Construction Traffic Management Plan – Five Dock Metro Station East & West Construction Sites

SMWSTCTP-AFJ-FDK-TF-PLN-00001 Revision 16

Sydney Metro West – Central Tunnelling Package

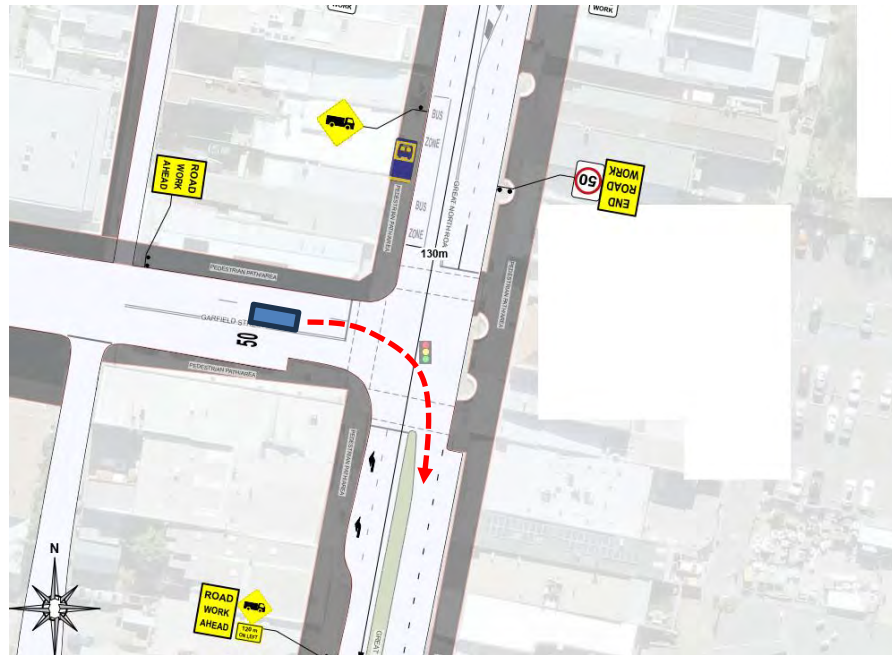
No.	Drawing No.	Description of Deficiency / Observation	Risk level
1	Stage 1 - AFJVCTP-TGS-00455 (page 2 of 11)	<p>The audit team observed that right turning motorists travelling EB on Garfield St on approach to Gt North Road will not pass an “END ROAD WORK” sign on departure of the site. As such, motorists may perceive that they are still within the vicinity of the work area which may increase the risk of motorist confusion.</p> <p>Furthermore, credibility may be decreased, motorists non-compliance and motorists confusion may be increased. Consequently, the risk of an incident occurring may be increased.</p>	<p>Likelihood – Unlikely Severity – Minor Risk Rating – Low</p>

Item	Location	Comment	Client's Response/Action for Resolution
1	Stage 1 - AFJVCTP-TGS-00455 (page 2 of 11)	<p>The audit team observed that right turning motorists travelling EB on Garfield St on approach to Gt North Road will not pass an "END ROAD WORK" sign on departure of the site. As such, motorists may perceive that they are still within the vicinity of the work area which may increase the risk of motorist confusion.</p> <p>Furthermore, credibility may be decreased, motorists non-compliance and motorists confusion may be increased. Consequently, the risk of an incident occurring may be increased.</p>	<p>Noted, all roadwork signage has been specifically placed in locations that allow, the available location of these signs is limited due to multiple overhead (shop front awnings, trees, etc), below ground (utilities) and footpath width conflicts.</p> <p>This does mean x2 side streets do not pass an end roadwork sign.</p>

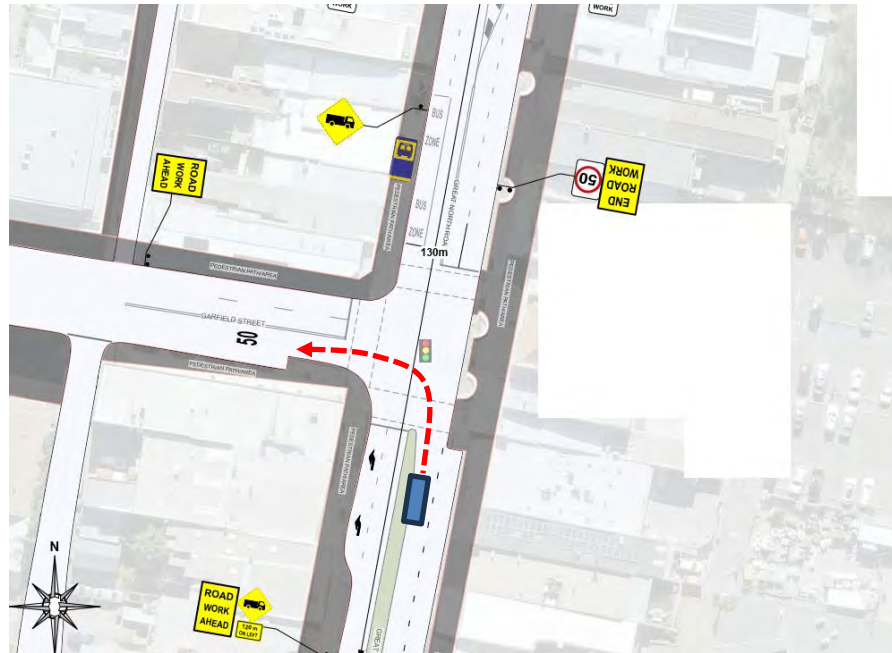
- 2 Stage 1 - AFJVCTP-TGS-00455 (page 1 of 11) Similar to finding #1, NB motorists on Great North Road turning left into Garfield Street do not seem to pass an “END ROAD WORK” sign which may have the same effect as explained in finding #1.

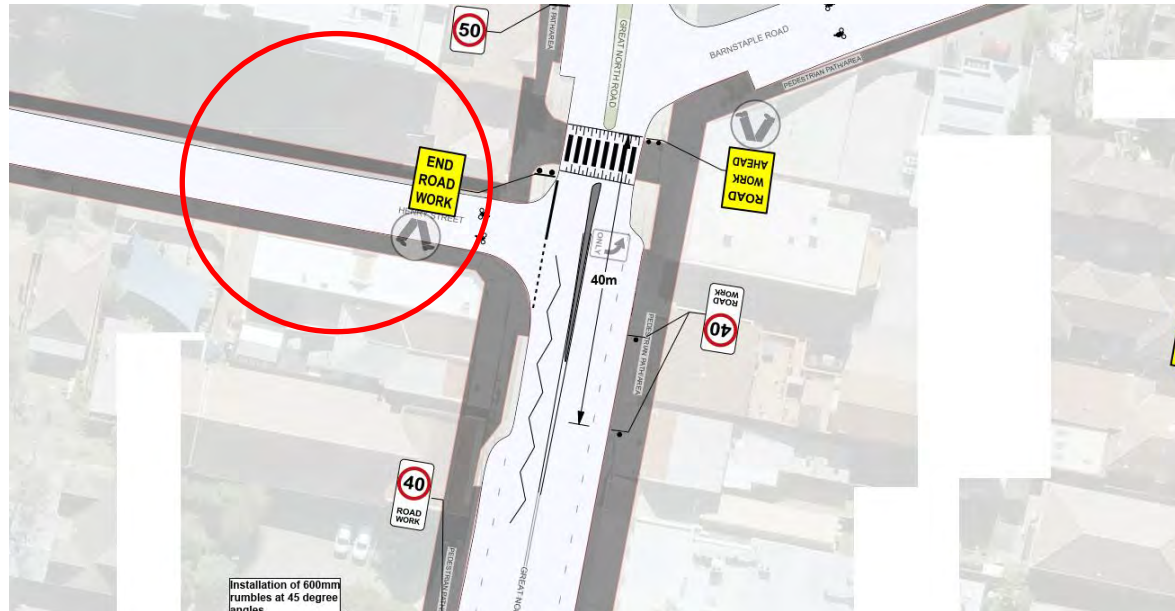
- 3 Stage 1 - AFJVCTP-TGS-00455 (page 1 of 11)

There appears to be an absence of site gate way signage within Henry Street. Consequently, motorists approaching or departing the site at Henry Street may not perceive the work zone which may increase motorists confusion (similar to findings #1 & #2) which may increase the risk of an incident occurring.

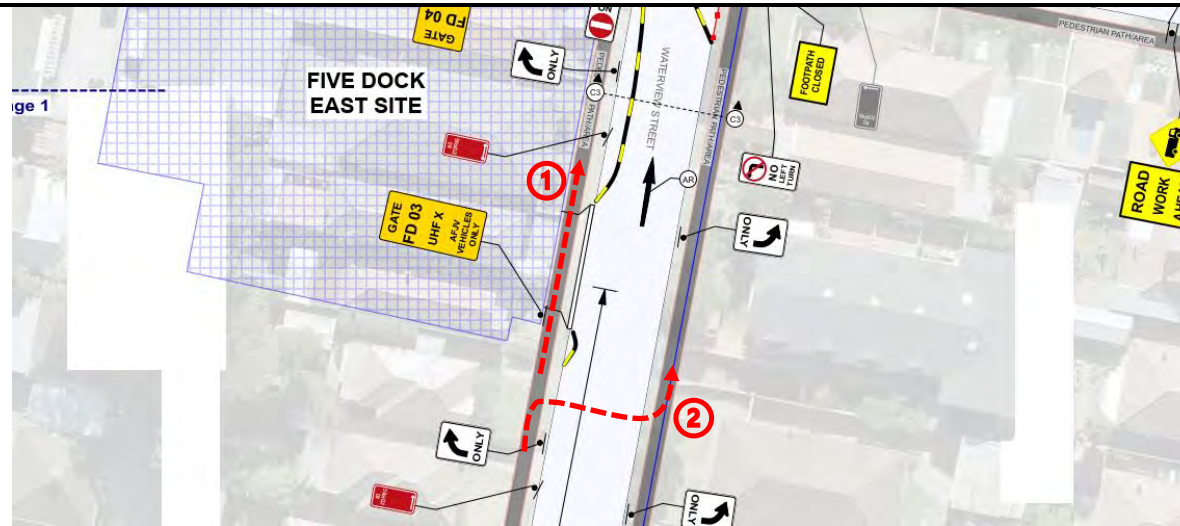
1. walk into the closed footpath area at Waterview St / Second Ave
2. have to cross at an informal crossing location prior to the work area at Waterview St / Second Ave

Both results will likely increase the risk exposure to pedestrians walking on the NB side of Waterview Street toward the proposed work area. See below depiction of each of the scenarios stated above.
